All SAF (Binkley) Mechanical Slide Boxes

Product Change Notification

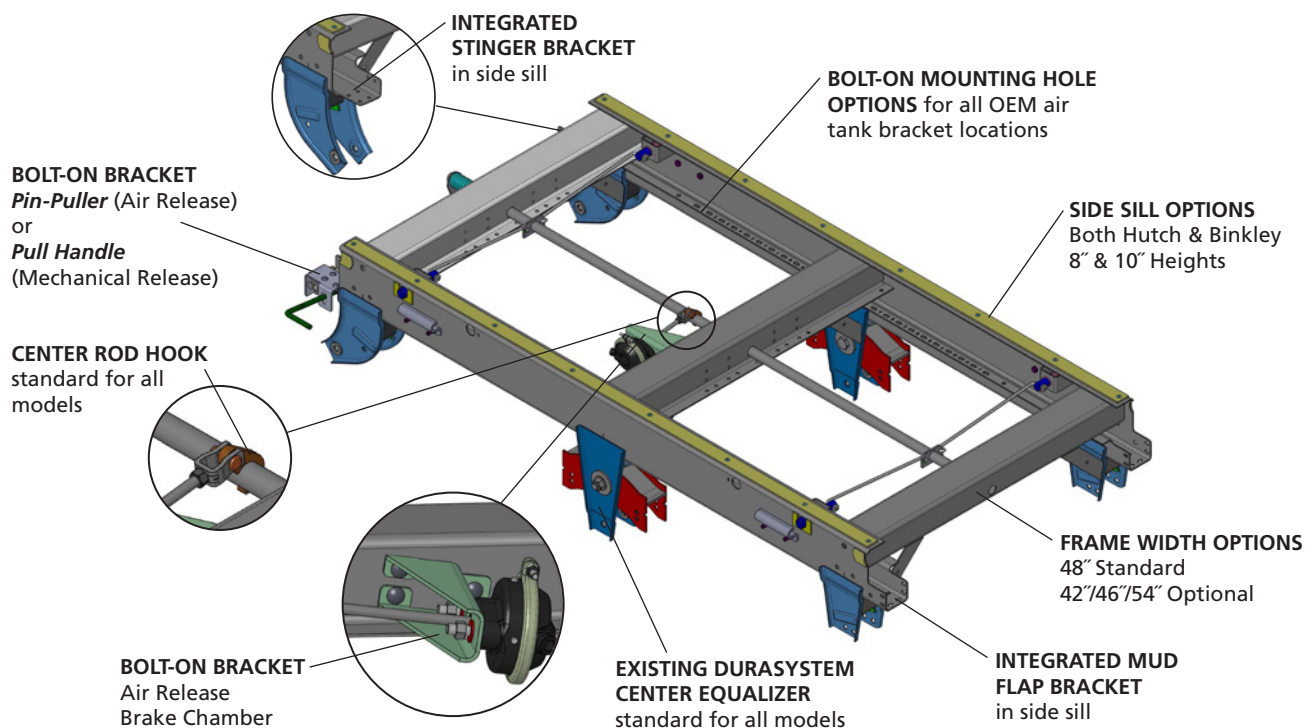
Beginning June 10, 2019, SAF-HOLLAND will be revising all mechanical slider assemblies per the illustration below. These product enhancements will reduce the number of slider variants, add mounting holes for bolt-on options, and reduce labor by eliminating extra welding.

- Integrated mud flap brackets
- Inner flange mounting holes for tank brackets
- Bolt-on pin puller/pull handle bracket
- Integrated front stinger bracket
- Bolt-on air release chamber bracket
- DURASYSTEM™ center equalizer standard for all models
- Center rod hook standard for all models

These changes will apply to all ULX and UltraLite Series Sliders. New part numbers will be created to facilitate the changes. Your OEM Account Sales Manager will be contacting you with more specific implementation timing and part number changes.
